**PARTS & SERVICE
NEWS**

REF NO.	AT02081
DATE	Jul. 18, 2002

SUBJECT: INTRODUCTION OF INJECTION PUMP MOUNTING BRACKET**PURPOSE:** To introduce a reinforced fuel injection pump mounting bracket for use with S, SA, SAA6D125 engines

Reinforced bracket
6152-25-6111

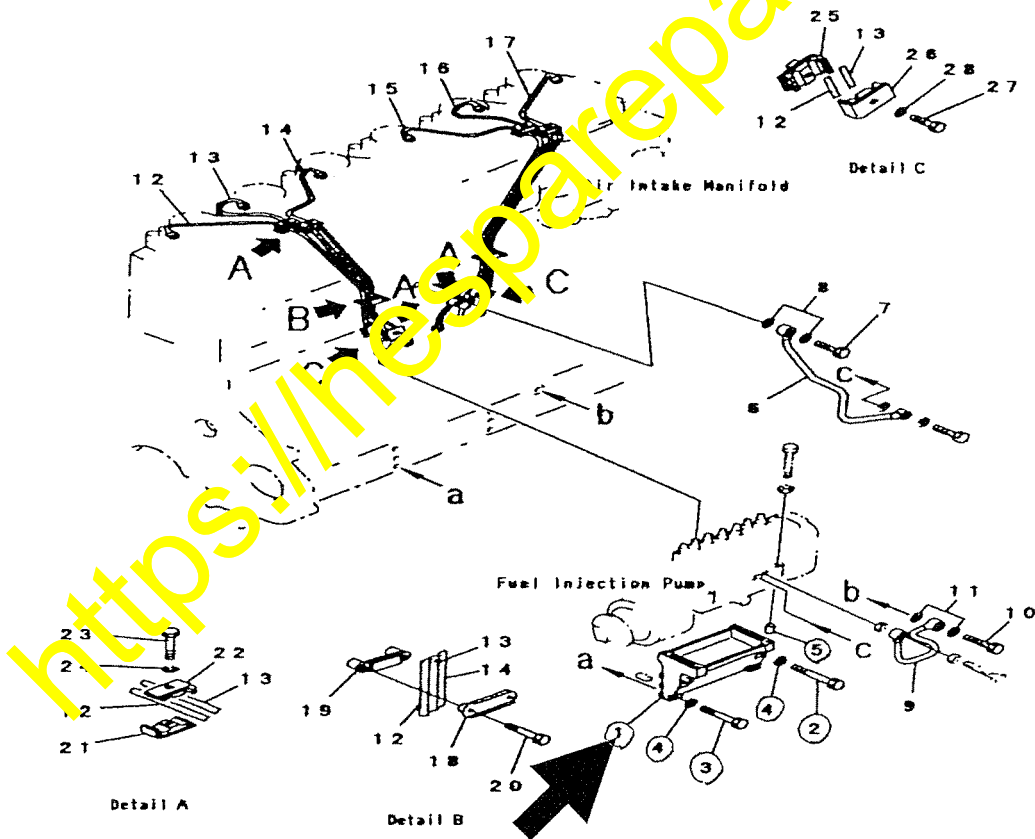
To improve the reliability and durability of the fuel injection system parts, the fuel injection pump mounting bracket for use with the S, SA, SAA6D125 engines has been changed to the reinforced type which is currently being used for marine engines to reduce the vibrations of the pump. This Service News will introduce the improved fuel injection pump mounting bracket.

※ The bolt length is different.

Be sure to replace the fuel injection pump mounting bracket with this improved type when overhauling.
